SUBDIVISION REVIEW SHEET

CASE NO.: C8-2013-0073.0A

SUBDIVISION NAME: Lot 3 & Lot 5 Blk A; Amended plat of Research Interchange II

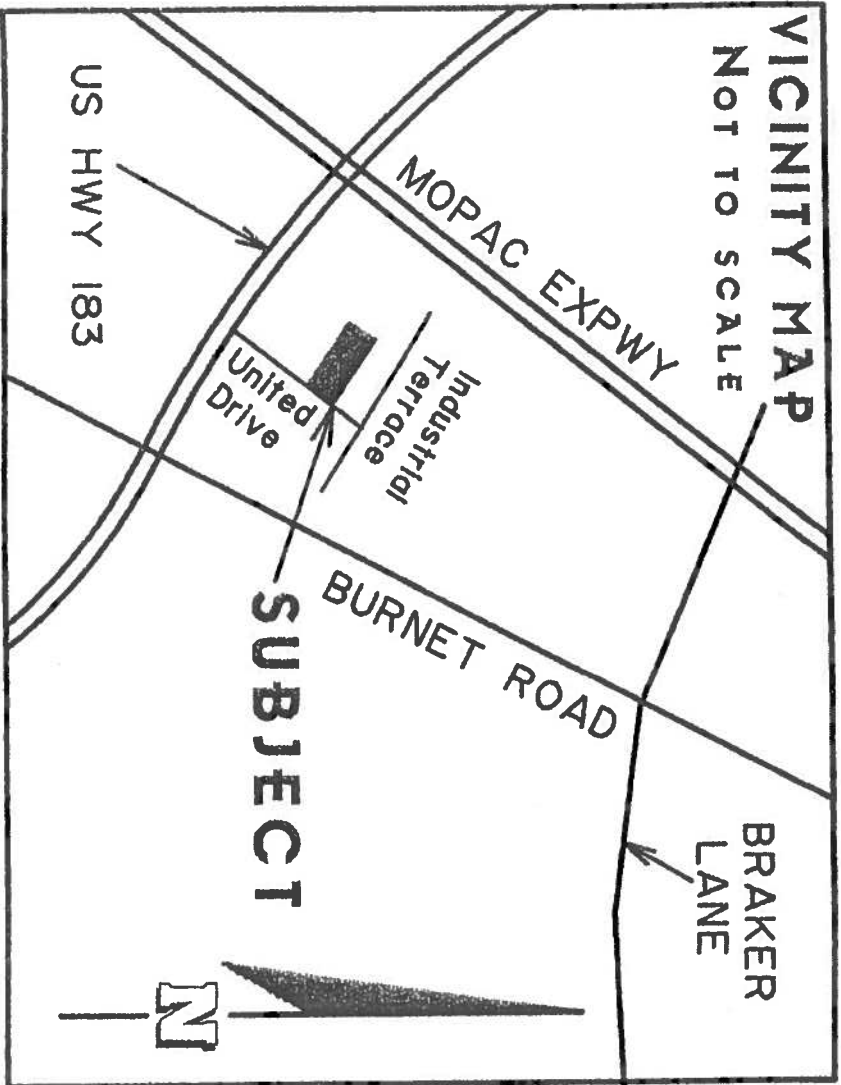
DEPARTMENT COMMENTS: The request is for approval of the Lot 3 & Lot 5 Blk A; Amended plat of Research Interchange II. The proposed plat is composed of 2 lots on 6.004 acres.

STAFF RECOMMENDATION: The staff recommends disapproval of the plat. This plat does not meet all applicable State and City of Austin LDC requirements.
